DMM Dragon size 4 and 5 Recall

15th of Feb 2011 - DMM has received information from a U.S retailer regarding size 5 (Blue) Dragon Cams. They have found cracks on the aluminium axle boss on two of the Dragon Cam size 5s they have in stock.

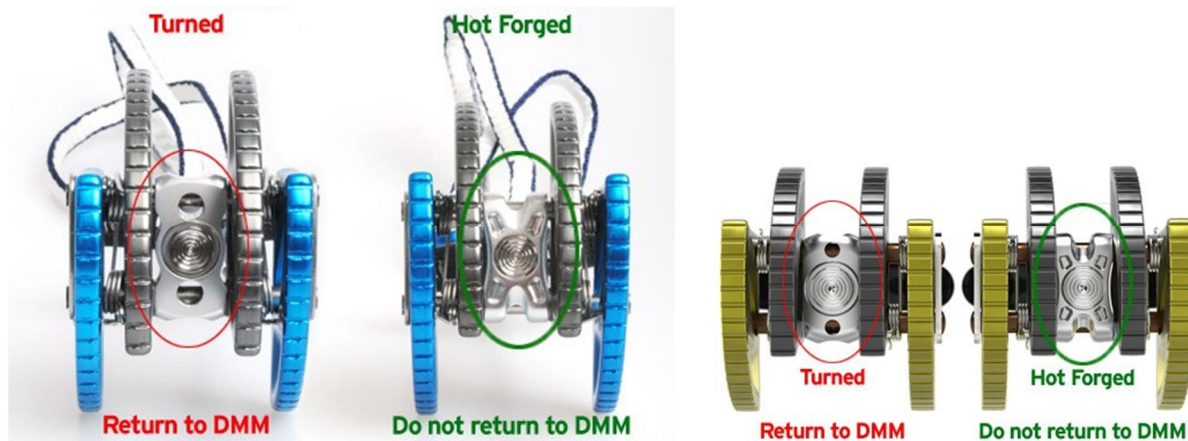
For the safety of all of our customers DMM are issuing an immediate recall for all Dragon Cams size 4 and 5 with turned axle bosses (see images below). At present there is no evidence that suggests the size 4 Dragon Cams are affected. However, we feel it appropriate to include them in the recall due to similarities in construction.

What to do: Customers should immediately stop using the DMM Dragon #4 & #5 and return the product to the place of purchase or post to:
